Service Bulletin

RRP Service Bulletin No: RRP SB394

Title: ATPI Dual PO Check Valve Kit

Product Series: Advanced Tie Plate Inserter [ATPI]

ATPI P.O. CHECK INSTRUCTIONS

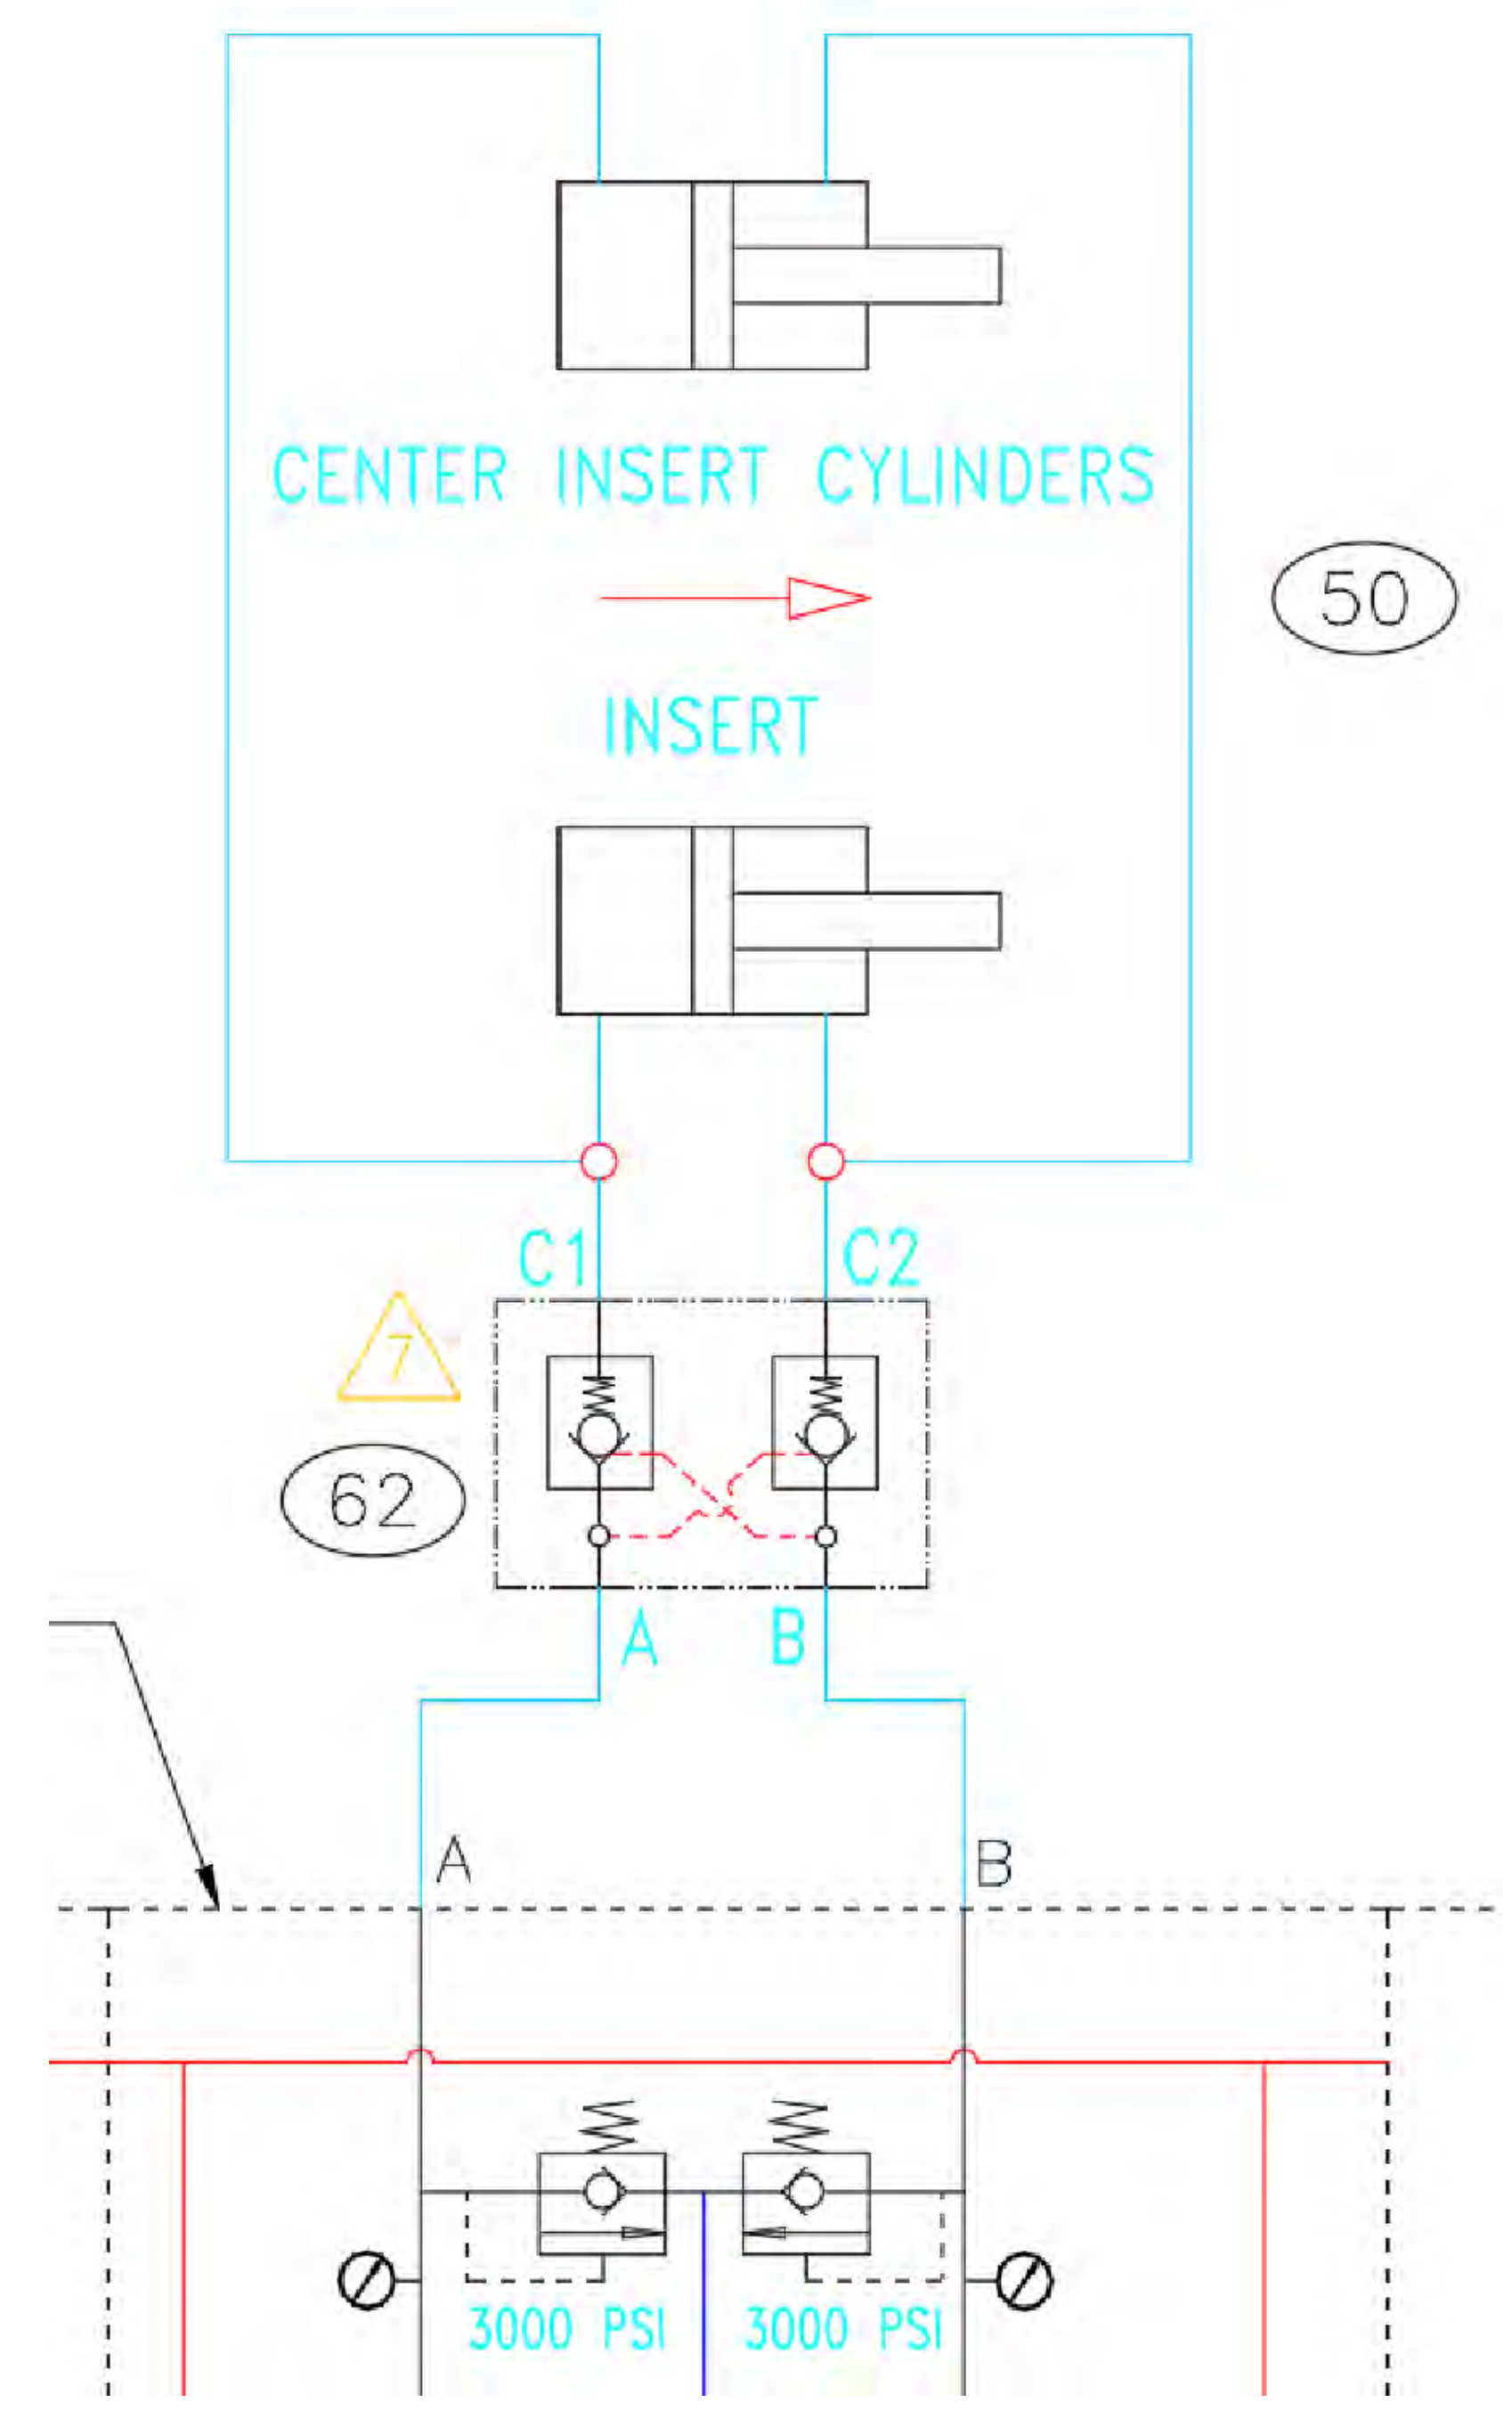
1. PERFORM LOCK OUT PROCEDURE TO THE MACHINE. MAKE SURE THE HYDRAULIC PRESSURE IS RELEASED AND THE WORKHEAD IS IN A SAFE STATE.
2. REMOVE THE P CLAMPS HOLDING THE WIRES AND GREASE LINES IN PLACE NEXT TO THE EXISTING BULK HEADS.

3. INSTALL THE (460157) ADAPTER X4 ON BOTH OF THE (466197) VALVES.
4. MARK AND REMOVE THE HOSES FROM THE EXISTING BULKHEAD A AND B ON BOTH SIDES.
5. REMOVE THE 45* ADAPTER THAT IS ON THE CMA SIDE OF THE BULKHEAD AND IT WILL BE REUSED ON THE NEW VALVE.

6. INSTALL THE NEW VALVE TO THE WELDMENT ON THE WORKHEAD FRAME ABOVE THE OLD BULKHEAD USING THE SUPPLIED HARDWARE (MAKE SURE IT IS ORIENTED CORRECTLY A & B TOWARDS THE CMA).

7. CONNECT HOSES COMING FROM THE CMA TO THE A & B PORTS (BE AWARE OF MOVING PARTS AND LENGTH NEEDED WHILE ROUTING HOSES).
8. INSTALL THE 45* ADAPTERS ON THE C1 AND C2 PORTS BUT LEAVE LOOSE.

9. CONNECT AND TIGHTEN THE HOSES TO THE C1 AND C2 PORTS (BE AWARE OF MOVING PARTS AND LENGTH NEEDED WHILE ROUTING HOSES).
10. ZIP TIE ALL LOOSE HOSES AND CABLES.

11. UNLOCK MACHINE.
12. E PUMP MACHINE TO FILL UP EMPTY HOSES.
13. USE MAINTENANCE MODE TO TEST THE FUNCTIONALITY, PLUMBING, AND MOVEMENT OF THE HOSES BEFORE GOING RIGHT BACK TO WORK.
